EXTENSIONS TO GLENMORE PARK, CHAIN-O-PONDS & THE NORTHERN ROAD, MULGOA

Road traffic noise investigation

TK045-01F01 Road Traffic Noise Investigation (r5)

APPENDIX F **Council's Internal Referral Comments with Renzo Tonin & Associates' responses**

Figure 1: Chain-O-Ponds & The Northern Road, Mulgoa - Concept Masterplan

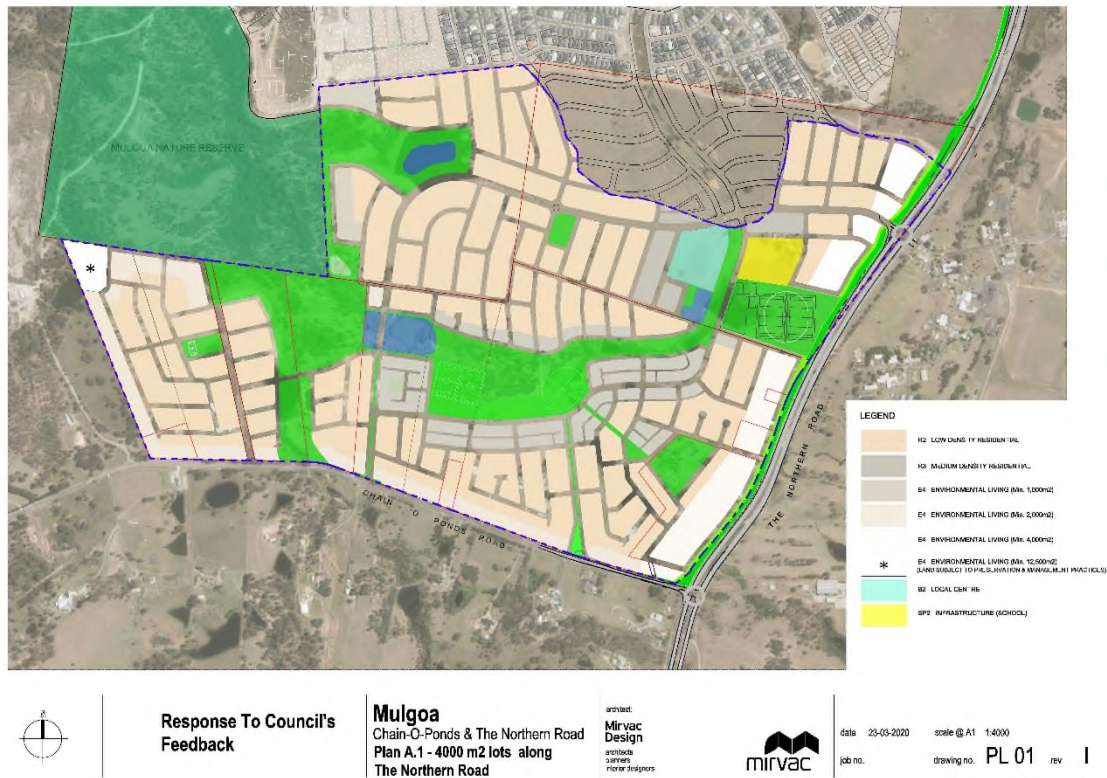
With the above in mind, it is important to set out now what noise mitigation strategies Council wants to encourage as part of the development of the area now. This will allow for easier changes to the proposed Master Plan as depicted in figure 4 of the Planning Proposal report. This would be the preferred option of the environment team, rather than waiting until the subdivision DA stage where applications are designed around the Master Plan (particularly the layout of roads and location of open space etc) and significant money spent on the plans and reports to support the application and significant delay in determining a DA occurs.

In also note that the proposed Master Plan does not appear to have any barrier between the sporting fields and The Northern Road. This aspect needs further discussion and resolution.

Figure 1 of the Acoustic Report has been updated with the latest masterplan

It is our understanding that noise mounds or barriers are not actively supported by Council as a source noise mitigation measure. The latest masterplan already includes a large separation of ~ 42m between The Northern Road boundary and the future residential dwellings (pathway noise mitigation measure) with any exceedance to be resolved through acoustic facade treatment (receiver noise mitigation measure). This is an acceptable strategy that has been replicated in many masterplanned subdivisions.

The latest masterplan has implemented the recommended solution of having perimeter service roads combined with executive housing fronting The Northern Road. In addition and according to the RNP, land use developers (such as Mirvac) must meet internal noise goals in the ISEPP and its Guideline with no external criteria applicable to 'new' residences along existing roads.

As discussed above, the level of exceedances i.e. 1-4dB(A) that can be expected in the area of the sporting fields closest to The Northern Road is minor. To include a noise mound/noise barrier in the design is unnecessary and we understand that the installation of such measures will obstruct important viewlines to the Blue Mountains from The Northern Road.
